SERVICE BULLETIN

Classification: BT09-079	Reference: NTB10-010	Date: January 19, 2010
-----------------------------	-------------------------	---------------------------

2009 370Z; SEAT POPPING NOISE/SLIGHT MOVEMENT FROM FRONT RIGHT SEAT CORNER

APPLIED VEHICLE: 2009 370Z (Z34) Left Side Manual Seat **ONLY**
APPLIED VIN/DATE: Vehicles built before JN1AZ44(**)9M 410159 / 26-Jun-2009

Figure 1

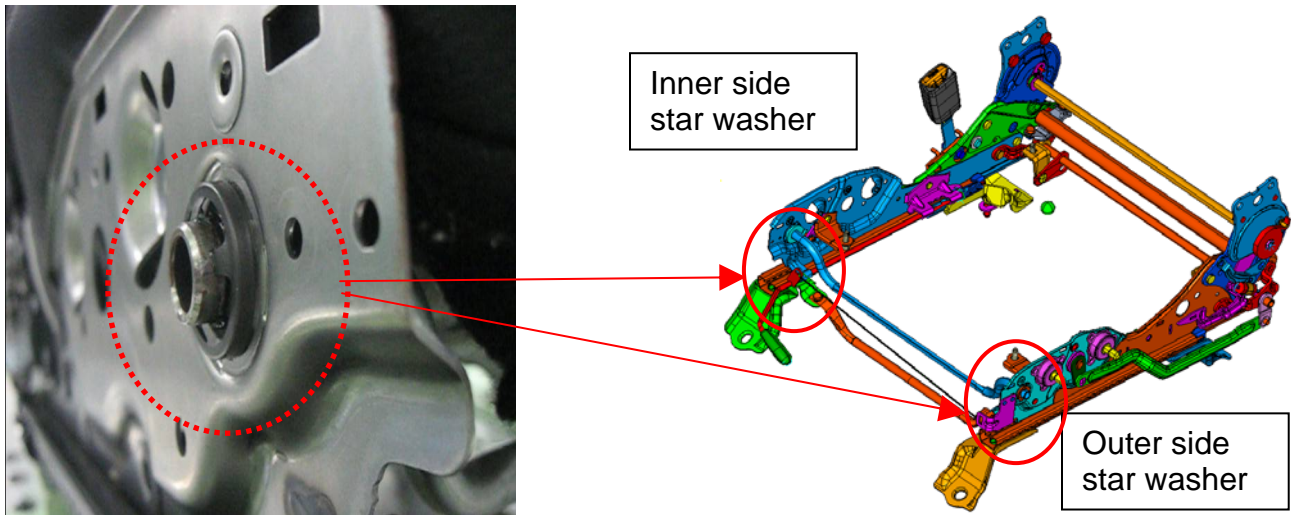
NOTE: Both the inner side AND outer side star washer being replaced in this procedure is shown below.

Figure 4

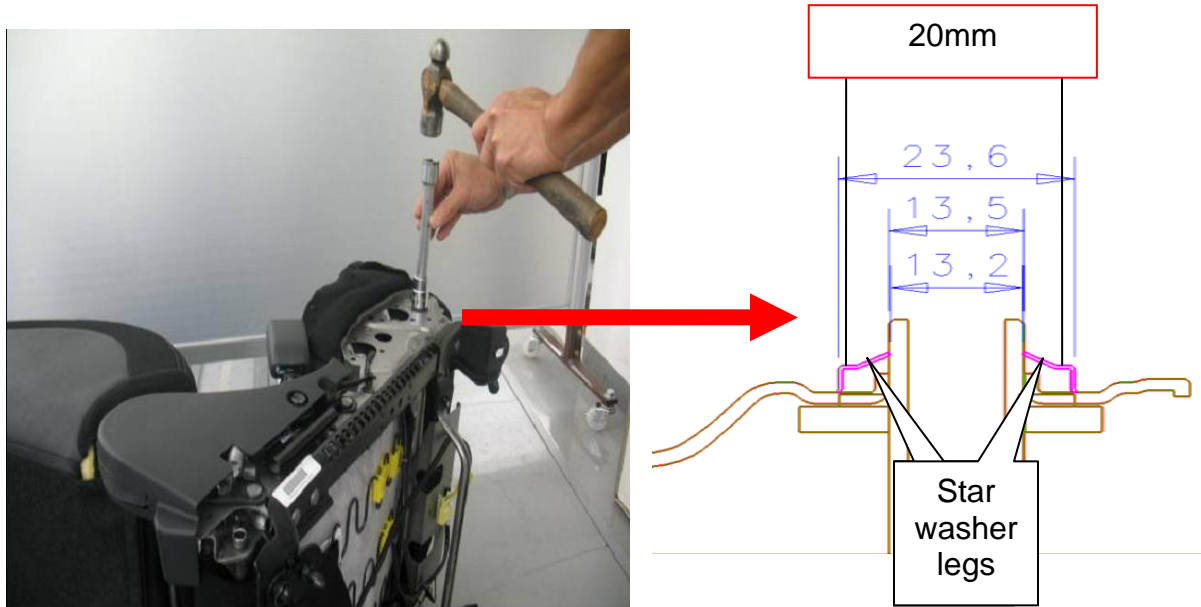
- 4a. Locate a pipe, socket, or similar tool with an internal dimension (ID) between 20 to 21mm that can be used as a drift. Ensure size is such that it does not interfere with “legs” of star washer (see Figure 4).
- 4b. Use tool to drive new star washer onto connector bar.

Figure 5

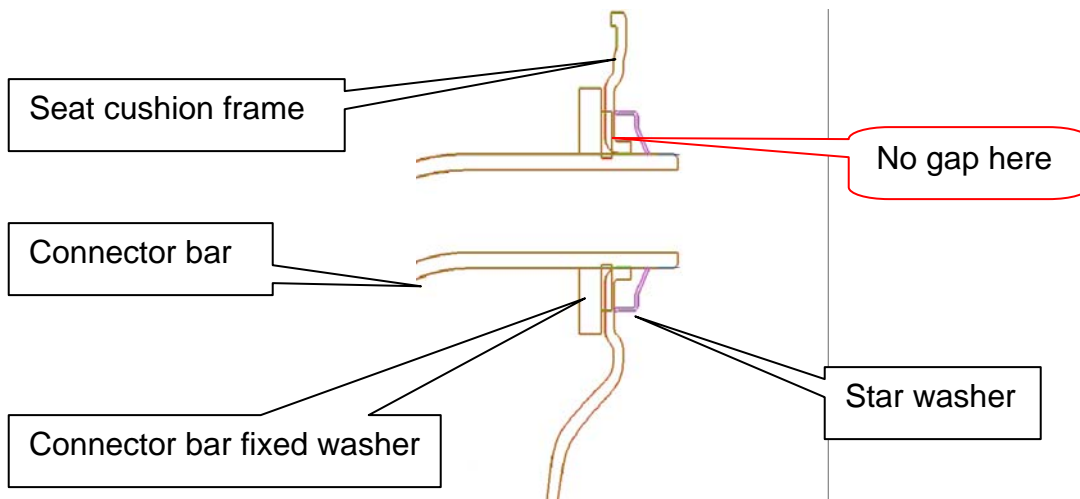
5. After drifting ensure star washer is fully seated against seat frame.
